## Concept Report Form

<b>Project Name</b>	Bridge over Branch									
<b>PIN</b>	134885.00									
<b>Route Information</b>	<b>Route</b>	<b>NHS (Y/N)</b>	<b>Functional Class</b>			<b>City</b>		<b>County</b>		
	S.R. 54	No	Rural Major Collector			Brownsville		Haywood		
<b>Project Information</b>	<b>Begin Log Mile</b>	<b>End Log Mile</b>	<b>AADT<sup>1</sup></b>	<b>Design Hour Vol. (DHV)<sup>1</sup></b>	<b>Truck %<sup>1</sup></b>	<b>Design Speed (MPH)</b>	<b>Posted Speed (MPH)</b>	<b>Base Year</b>	<b>Design Year</b>

**Comment Resolution: 134885.00, Haywood, SR 54, Bridge over Branch (TMA)**

## ENVIRONMENTAL TECHNICAL STUDY AREA

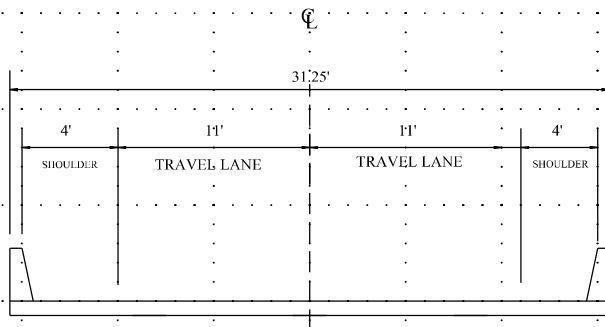
Consider combining the ETSA boundaries from Figure 1a and Figure 2a. A single ETSA should be reasonably conservative to minimize the risk of a Reevaluation.

Draft Report Review (OSD2)	Environmental	Kate Landers	10/16/2024	NEPA: Consider combining the ETSA boundaries from Figure 1a and Figure 2a. A single ETSA should be reasonably conservative to minimize the risk of a Reevaluation.	Yes	ETSA boundaries combined into one sheet.
Draft Report Review (OSD2)	Pre-Construction	Kyle Garcia	11/4/2024	Curve layout for realignment scenario needs to be evaluated to ensure it meets the design requirements for a design speed of 60 mph.	Yes	This will be updated
Draft Report Review (OSD2)						
Draft Report Review (OSD2)						
Draft Report Review (OSD2)

\*Note: ETSA boundary combines Figure 1 & 2.
